Additional Proposal for the 01 series of amendments to Regulation No. 129 (Enhanced Child Restraint Systems)

Proposal

figure 1

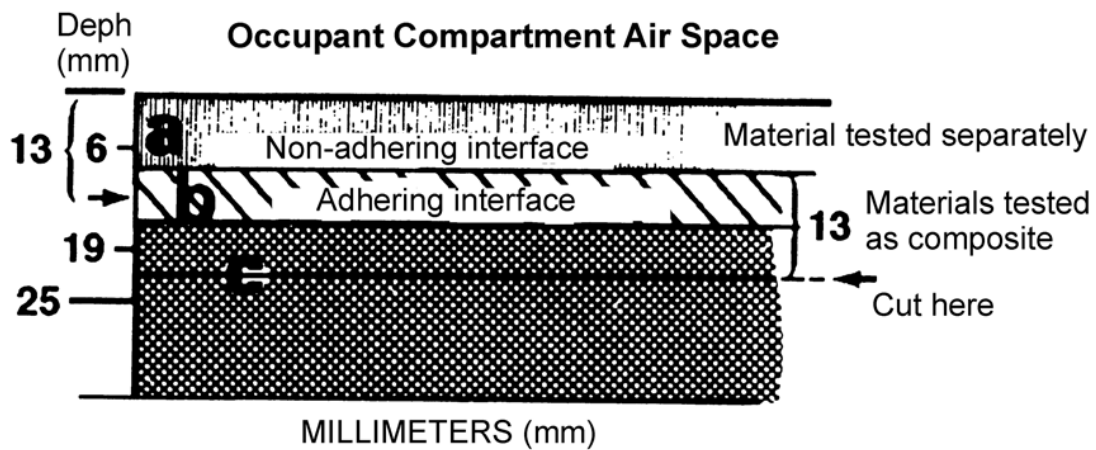
2. Material selection (see Figure 1 below)

2.1. Any portion of a single or composite material which is within 13 mm of the occupant compartment air space shall meet the requirements in Paragraph 6.1.6.

2.1.1 Any material that does not adhere to other material(s) at every point of contact shall meet the requirements of Paragraph 6.1.6. when tested separately

2.1.2 Any material that adheres to other materials at every point of contact shall meet the requirements of Paragraph 6.1.6. when tested as a composite with the other material(s).

Material A has a non-adhering interface with material B and is tested separately.

Part of material B is within 13 mm of the occupant compartment air space,

and materials B and C adhere at every point of contact; therefore, B and C are tested as a composite. The cut is in material C as shown, to make a specimen 13 mm thick.

Figure 2

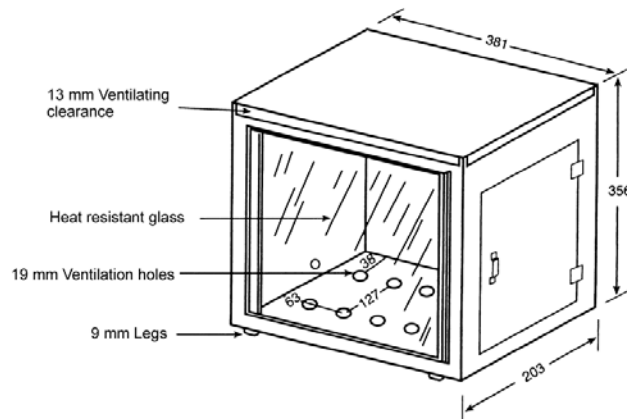
3.1 The test is conducted in a metal cabinet for protecting the test specimens from drafts. The interior of the cabinet is 381 mm long, 203 mm deep, and 356 mm high. It has a glass observation window in the front, a closable opening to permit insertion of the specimen holder, and a hole to accommodate tubing for a gas burner. For ventilation, it has a 13 mm clearance space around the top of the cabinet, ten holes in the base of the cabinet, each hole 19 mm in diameter and legs to elevate the bottom of the cabinet by 10 mm, all located as shown in Figure 2.
